June 25, 1985

DCR  
064

PRAIRIE ISLAND NUCLEAR GENERATING PLANT UNIT NO. 1

Amendment No. 73  
License No. DPR-42

FIGURE TS.6.1-1 NSP CORPORATION ORGANIZATION  
RELATIONSHIP TO ON-SITE  
OPERATING ORGANIZATIONS

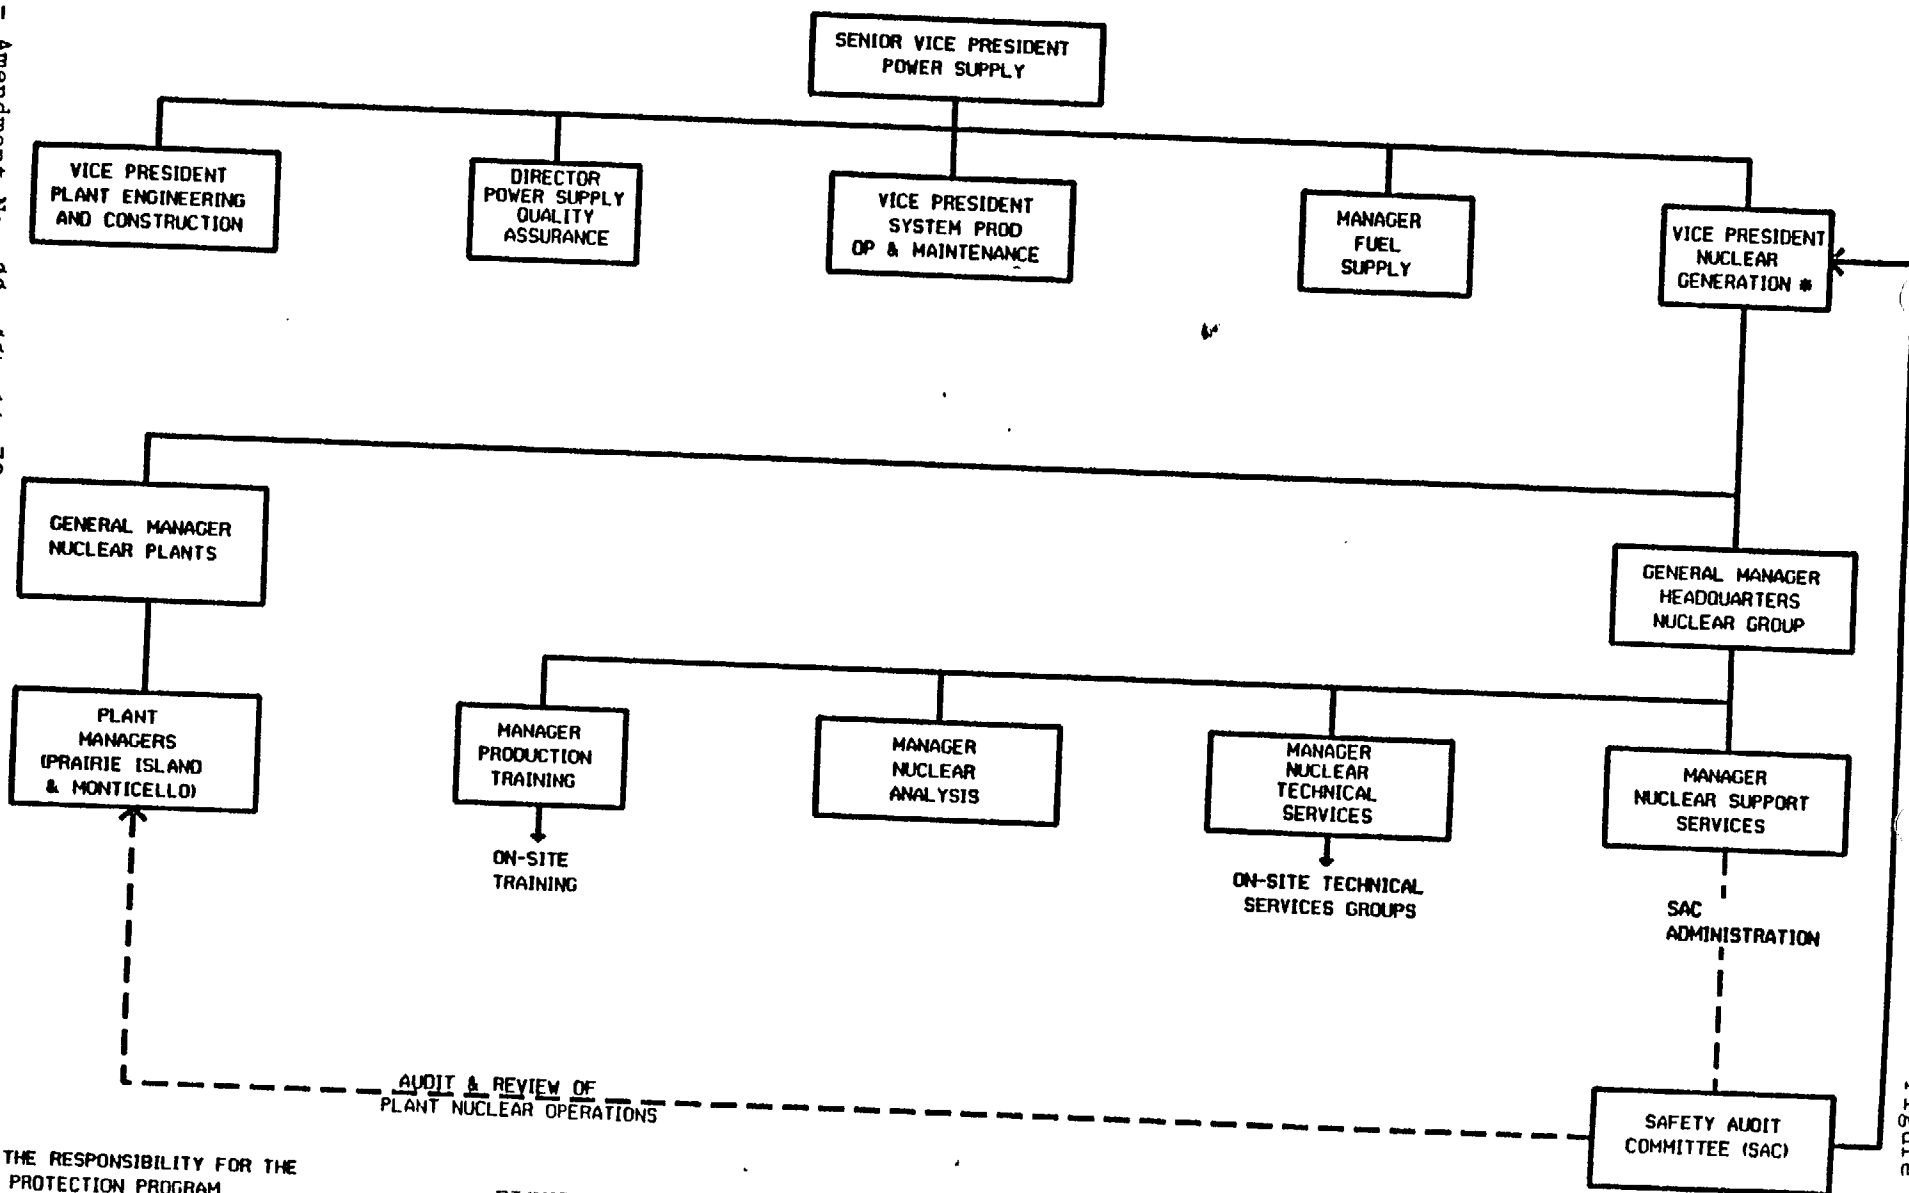
9. Delete unnecessary testing related to radioactive effluent monitor instrumentation (TS 3.9-2 table, TS 4.17-1 table);
10. Clarify TS wording related to radiation environmental monitoring program sampling (TS 4.10-1 table); and
11. Change the title of the Director of Nuclear Generation to Vice President Nuclear Generation (TS 6.2 and TS 6.1-1 Figure).

11. TS 6.1-1 table, TS 6.2 and TS 6.7 title change

The licensee proposed the title of "Director of Nuclear Generation" be changed to "Vice President Nuclear Generation. The administrative sections of the TS reflect the change by modifying the title of the Director of Nuclear Generation to Vice President Nuclear Generation. The title change would make the title appearing in the TS agree with the title existing in the actual plant organization. This change is administrative in nature and has no effect on the management function, authority or responsibility of the position identified throughout the administrative sections of the TS. On this basis, the staff concludes that the change will not reduce the level of plant safety and, therefore, is acceptable.
